**TOWNHOUSE DEVELOPMENT**

19 FORBES STREET  
BLOCK 4 SECTION 46 TURNER

<b>Representation received: DA201833361 Block 4 Section 46 Turner</b>	
<b>Issue</b>	<b>Response</b>
<ul style="list-style-type: none"> <li>• Respondents expressed the view that the lease holder has no right to remove the driveway because "Buyer beware"</li> </ul>	
<b>Driveway Layout</b>	
<ul style="list-style-type: none"> <li>• Respondent concerned driveway layout interferes with services Respondent concerned driveway layout is non-compliant</li> </ul>	<ul style="list-style-type: none"> <li>• Driveway layout has been submitted to utility providers and TCCS and is supported by these entities</li> </ul>
<b>Pedestrian Basement Access</b>	
<ul style="list-style-type: none"> <li>• Respondent concerned basement parking does not have a separate pedestrian access for emergencies</li> </ul>	<ul style="list-style-type: none"> <li>• Separate pedestrian access to the basement is not required</li> <li>• Basement has access via internal stairways for emergencies</li> </ul>

I, Richard Davies, delegate of the planning and land authority, pursuant to section 162 of the *Planning and Development Act 2007*, hereby **approve sub

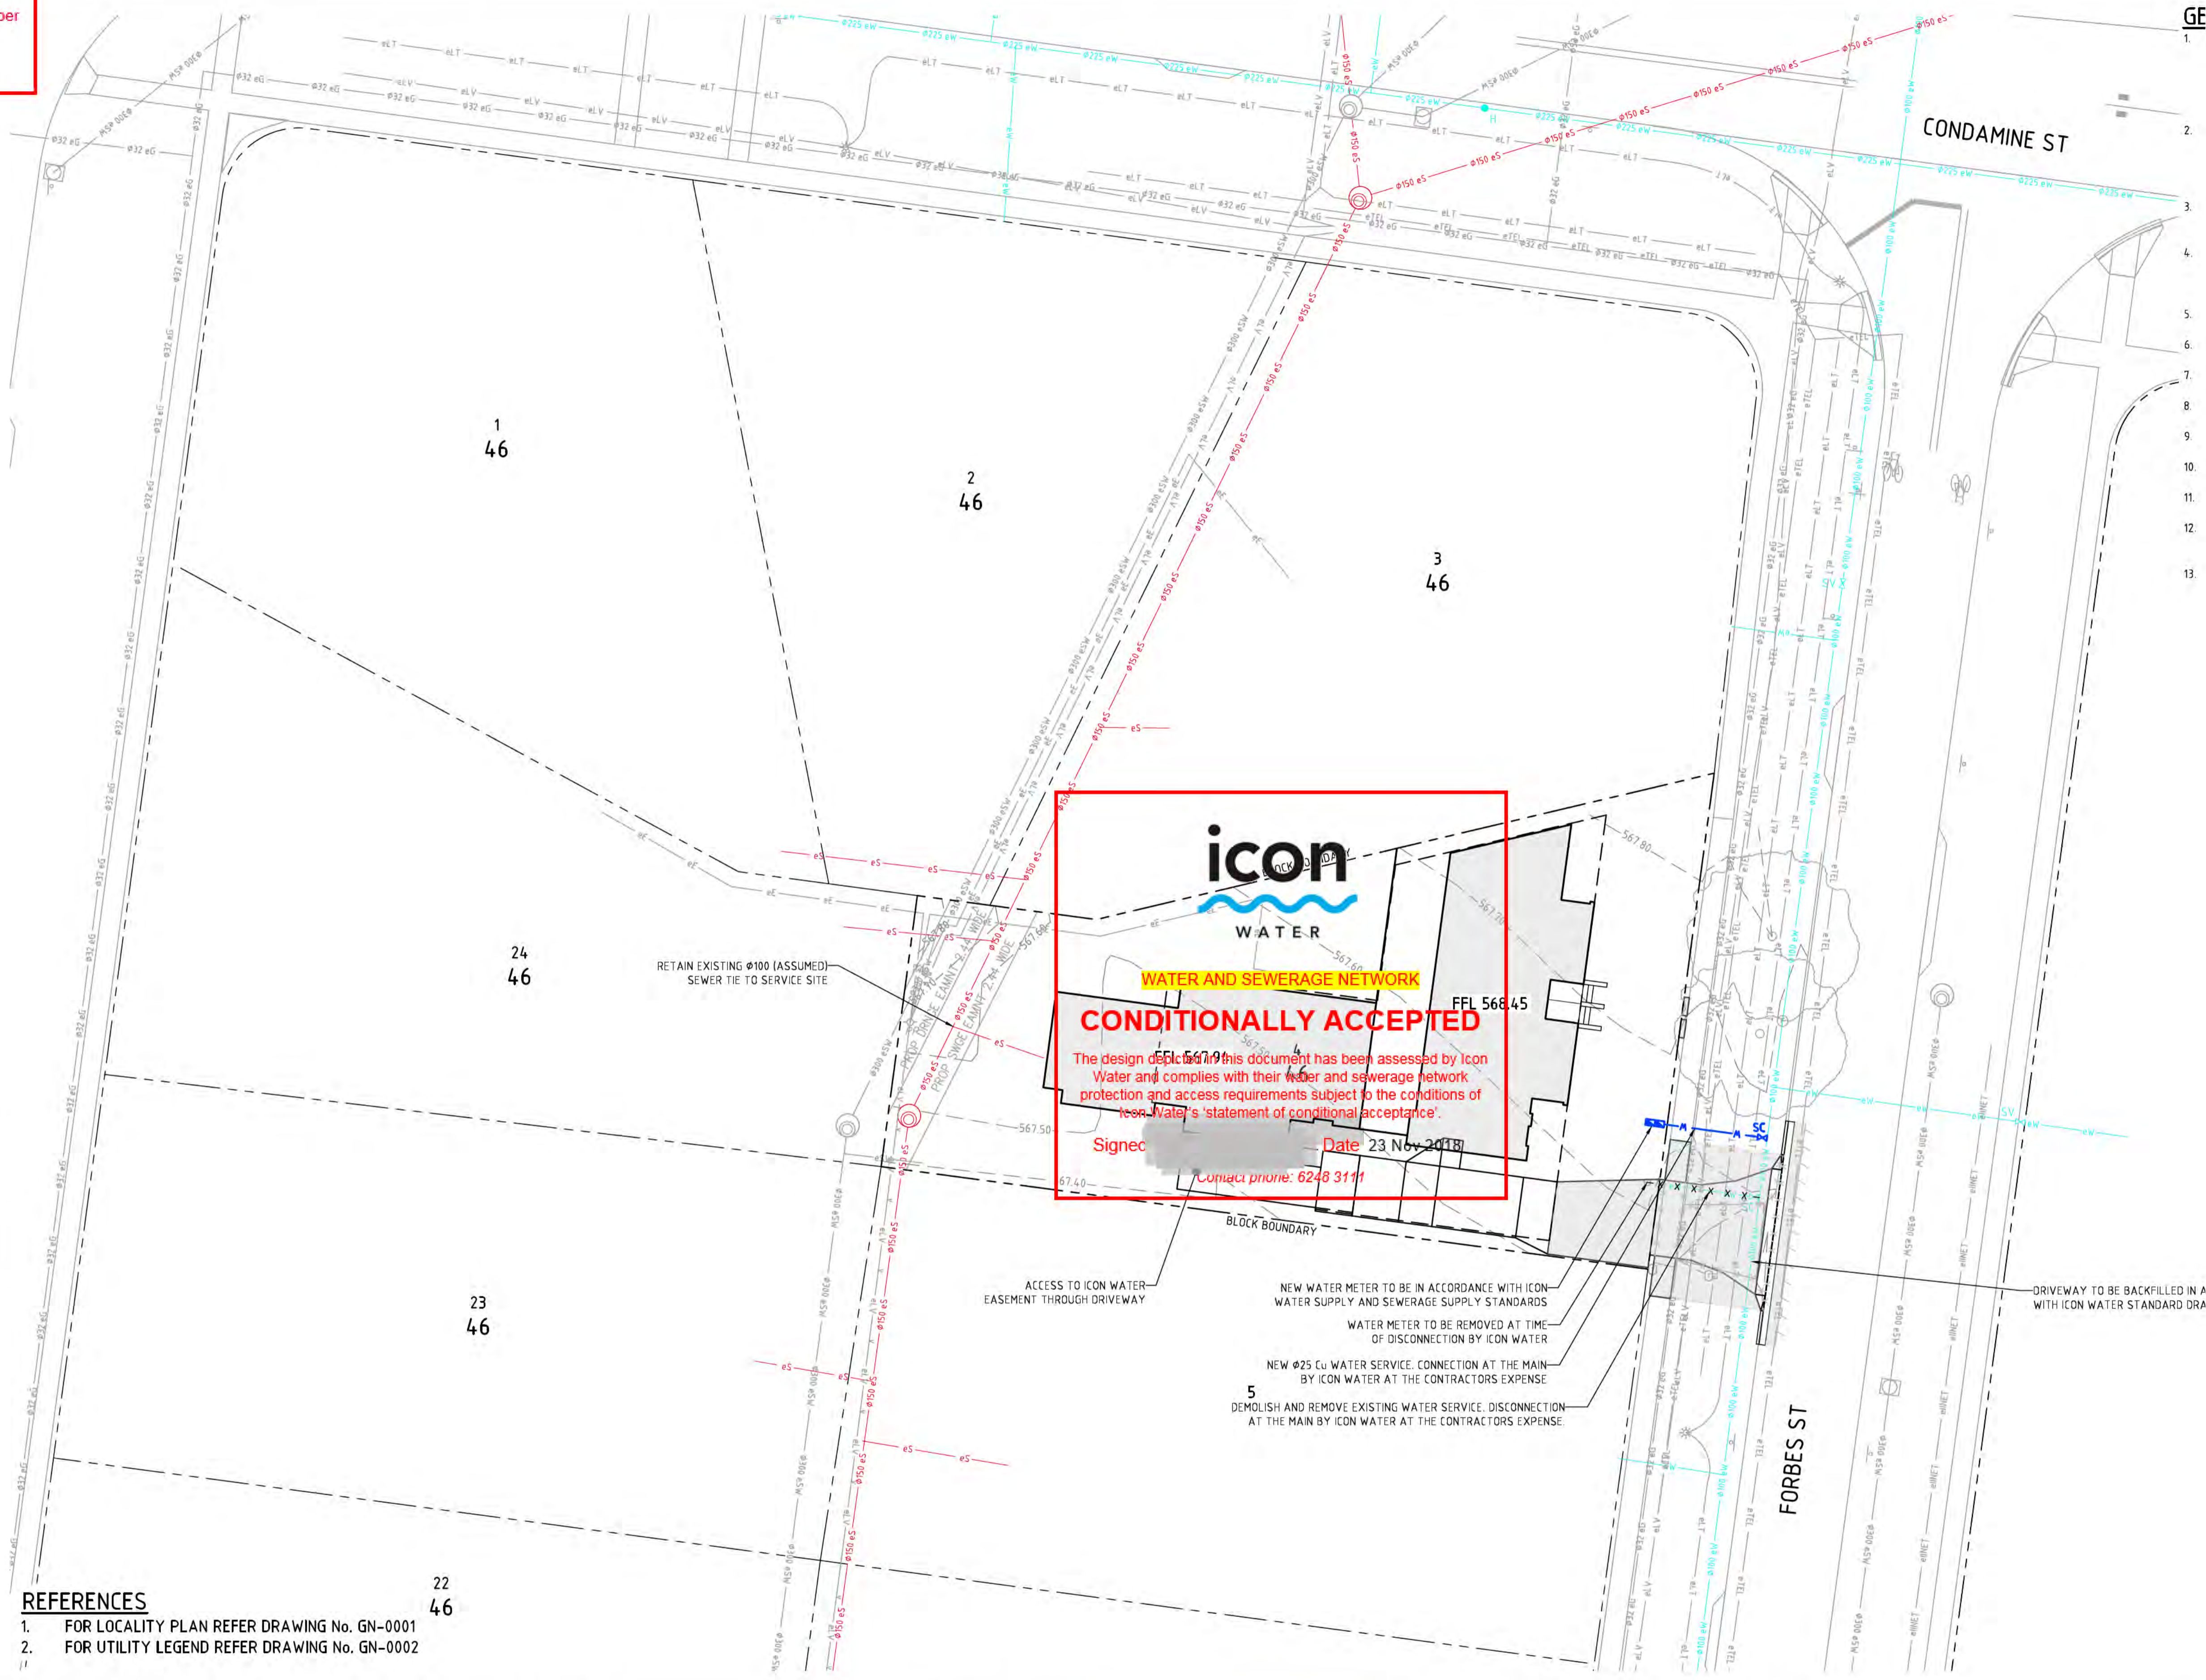
As discussed, there is an on-going issue regarding a boundary encroachment. The driveway of adjoining block 3 encroaches into the subject block which can be identified on the demolition plan submitted with the S144B documentation. A condition has been included in Part A regarding the encroachment, which George has cleared.

Work within the boundary encroachment on the north eastern corner of Block 4 Section 46 Turner, as identified on drawing 0301 – revision 'G', must not commence until the driveway of Block 3 Section 46 Turner has been relocated and completed so that it is sited wholly within the property boundaries of Block 3 Section 46 Turner.

**TOWNHOUSE DEVELOPMENT**  
19 FORBES STREET  
BLOCK 4 SECTION 46 TURNER  
**LANDSCAPE CONCEPT PLAN**  
**EXTERNAL LIGHTING PLAN**  
SCALE 1:100 @ A2  
14/08/2018  
**FSP005**

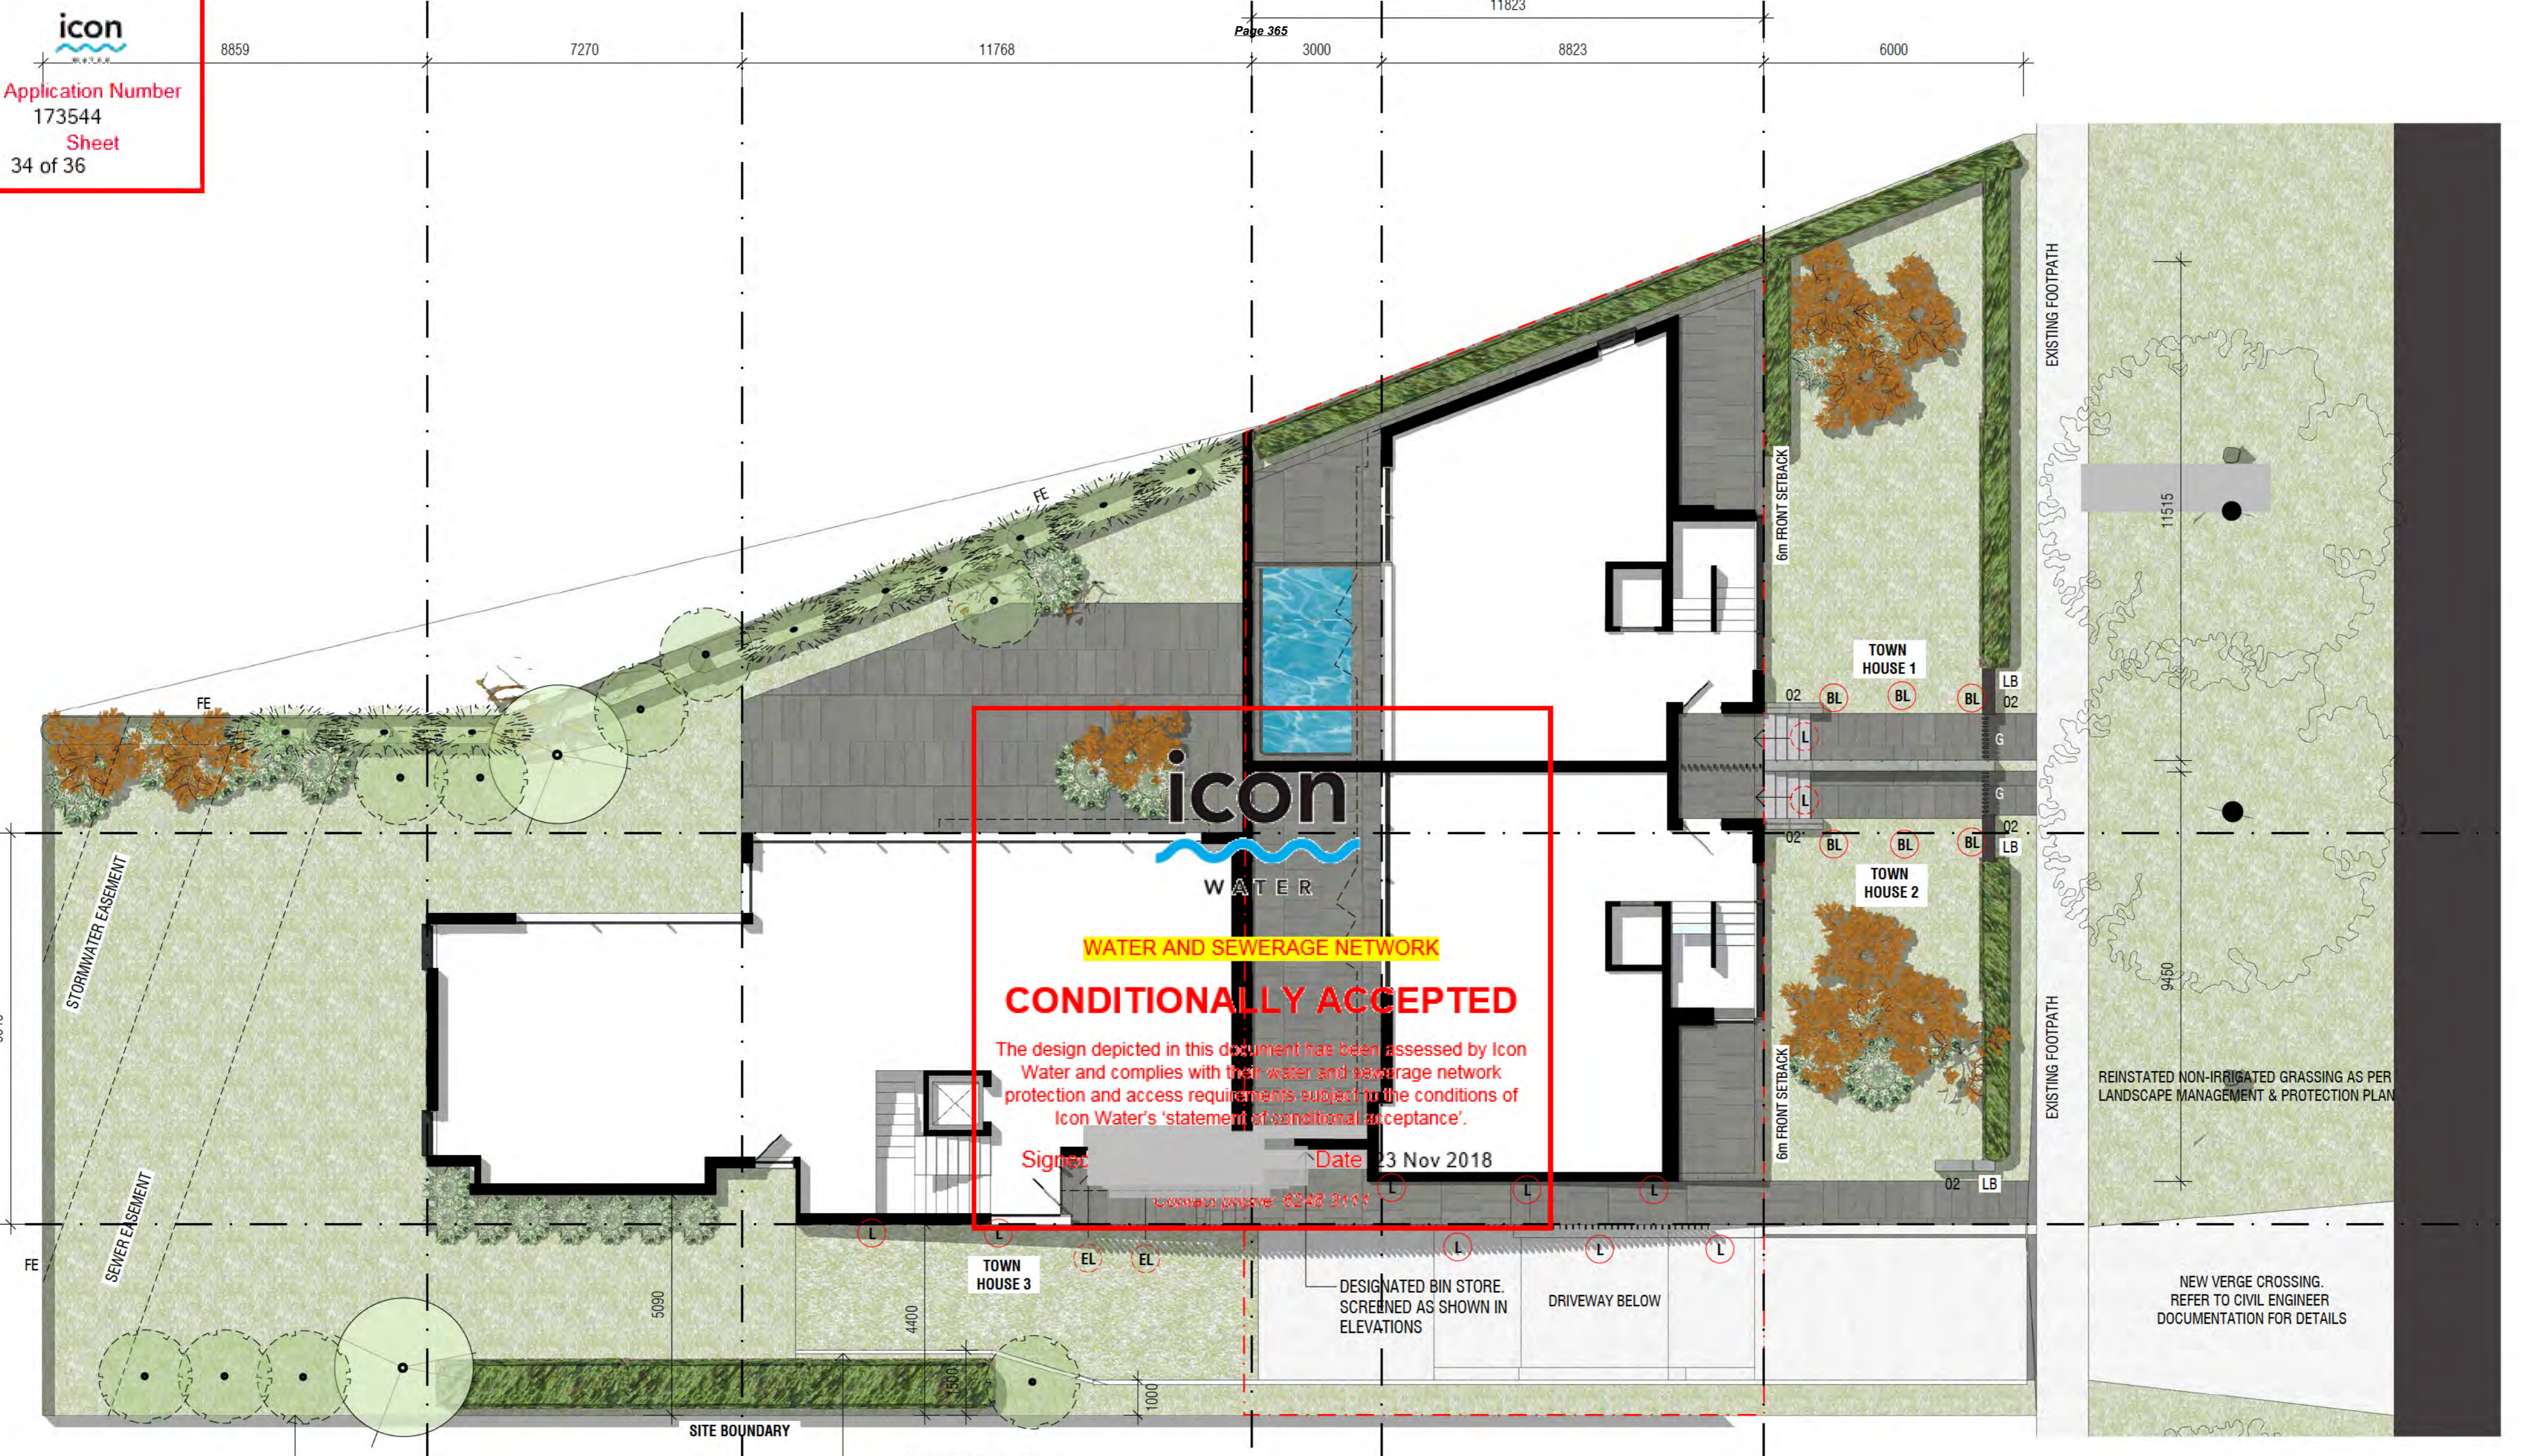
C40	More plants area introduced in the revised Landscape Plan. But plants details are not shown. <b>A condition is required.</b> Details of the retaining wall is required
	R42 & C42	<b>Courtyard wall detail is required</b>
	C43	Water tank shown on revised floor plan. Mechanical services and cloths lines not indicated on plans.
	R72 & C72	The amendment application S144 referred to TCCS
	R73 & C73	Planting details required along driveway
		The demolition plan submitted with S144 application confirmed that part of the driveway of the adjoining block 3 proposed to be removed. A further notification is required and a request for further notification sent to the relevant stage.

- a) revised site plan, landscape plan and architectural drawings, based on the relevant drawings submitted as part of the application, showing:
  - i) Detailed Landscape plan that includes the size and species of proposed plants, including those plants proposed along the driveway;
  - ii) Detail of the proposed retaining wall; and
  - iii) A courtyard wall detail indicating the height, length, and material of the courtyard walls of units 1 & 2.
